PLANNING COMMISSION STAFF REPORT

SUBJECT: REQUEST BY GANDO PROPERTIES FOR A MAJOR ARCHITECTURAL APPROVAL AND A VARIANCE APPLICATION TO CONSTRUCT AN APPROXIMATELY 103,943 SQUARE-FOOT OFFICE SPACE, WAREHOUSE AND SELF-STORAGE FACILITY ON AN APPROXIMATELY 4.5-ACRE PARCEL LOCATED AT THE SOUTHEAST CORNER OF GENE AUTRY TRAIL & TACHEVAH DRIVE, ZONE M-1-P, (3.3830-MAJ & 6.542-VAR), (ER/FF).

'PRELIMINARY' PLANTING PLAN

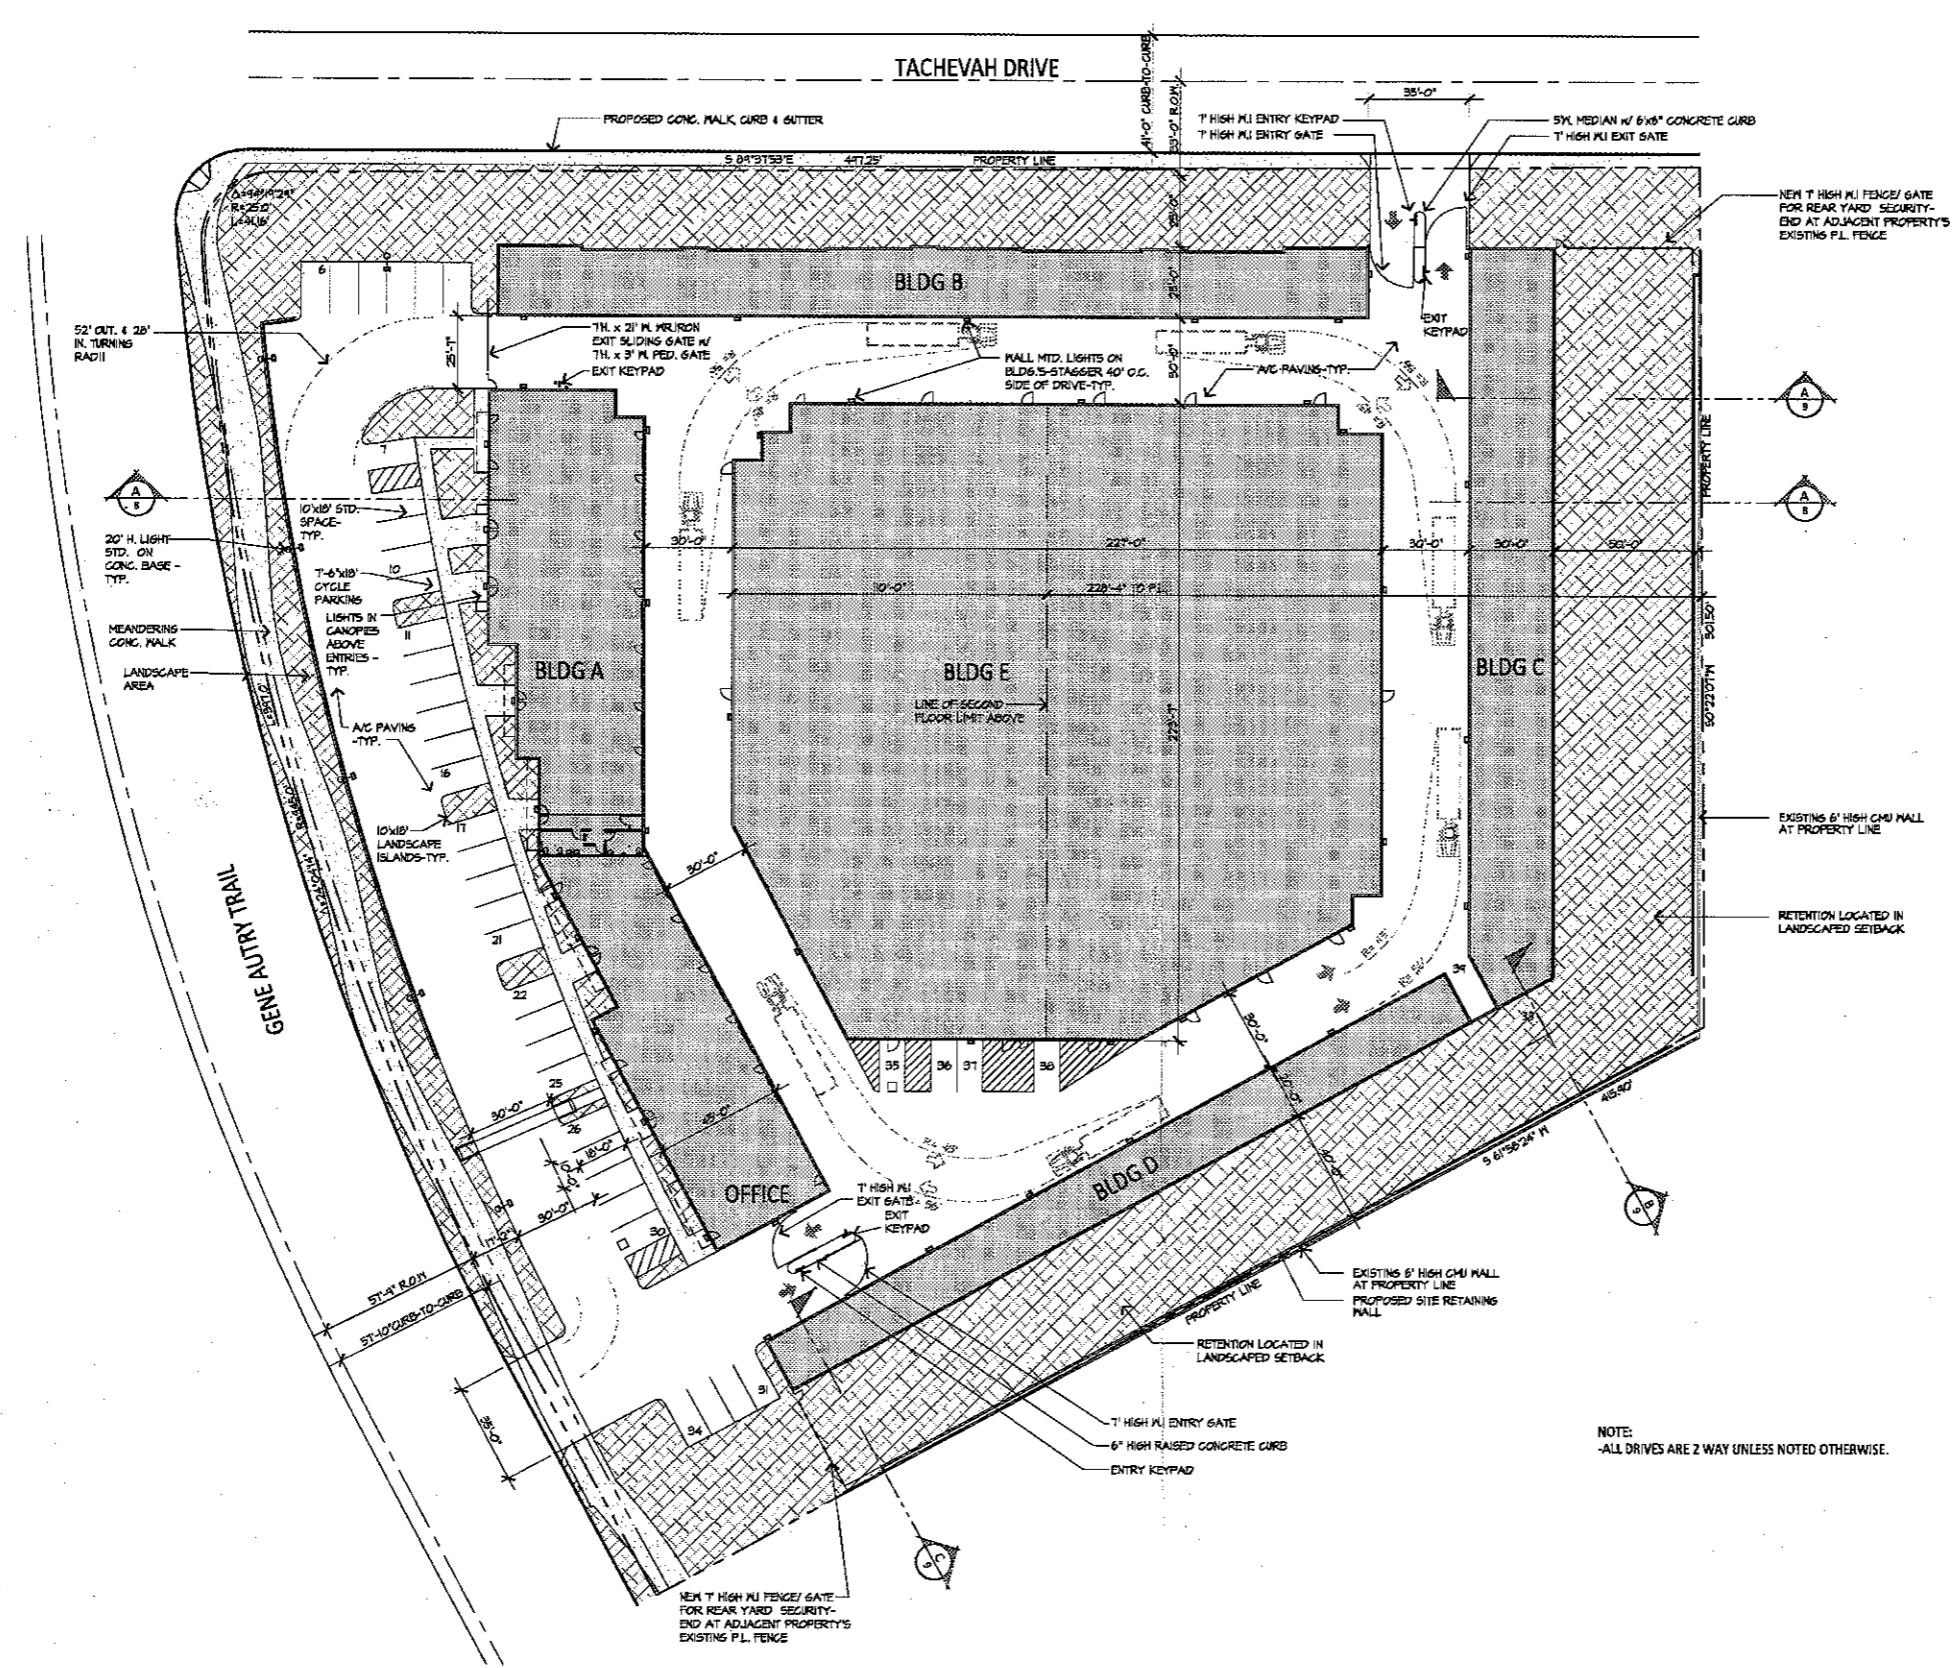
Member Hirschbein verified the number of trees along Tachevah (4 trees on landscape plan versus 8 on the elevation).

Member Hirschbein said the site plan is very clever; however, the landscaping needs to be more substantial.

Vice-Chair Fredricks said landscape needs additional lushness and an increase in agave plant sizes (mix 5 and 15 gallon plant sizes).

COLLIN SALVADOR, Sunshine Landscape, cited the changes made to the landscape plan:

1. Increased plant material;
2. Increased decomposed granite size;
3. Variation in plant heights from front to back;
4. Increased plantings at corners.

BLDG. B NORTH ELEVATION (OVERALL)
SCALE: 1" = 16'-0"

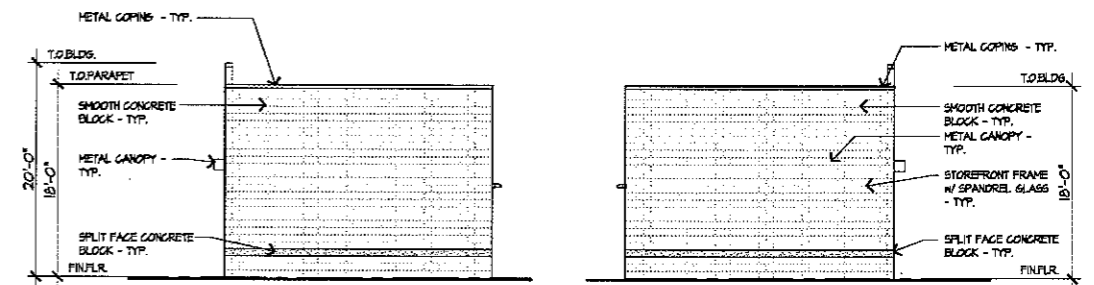
- Consider better building massing and composition of the Tacheva building elevation and match landscape accordingly;
- Increase the sizes of some of the accent plants from 5 gallon to 15 gallon size;
- Consider the location of the site relative to wind issues;
- Increase tree sizes to 36" and 48" box size for all trees and increase the tree count;
- Add articulation to wall masses and match the design elements in Building A;
- Add trees along the Tachevah frontage in front of Building B to mitigate the reduced setback; and
- Consider raising the height of Building B to assure the screening of Building E.

1. Consider better massing/composition on Tachevah and match landscape.
2. Increase sizes of some Desert Accent plantings from 5 gal. to 15 gal.

3. Consider the location of the site relative to wind issues
4. Increase tree sizes to 36" and 48" box for all trees and increase tree count.
5. Add articulation to wall masses to better match the design elements in Building A.
6. Add trees along Bldg. B on Tachevah frontage to mitigate proposed setback variance.
7. Consider raising the height of Building B to assure screening of the large Bldg. E.

The project has been revised to incorporate most of the recommendations of the AAC.
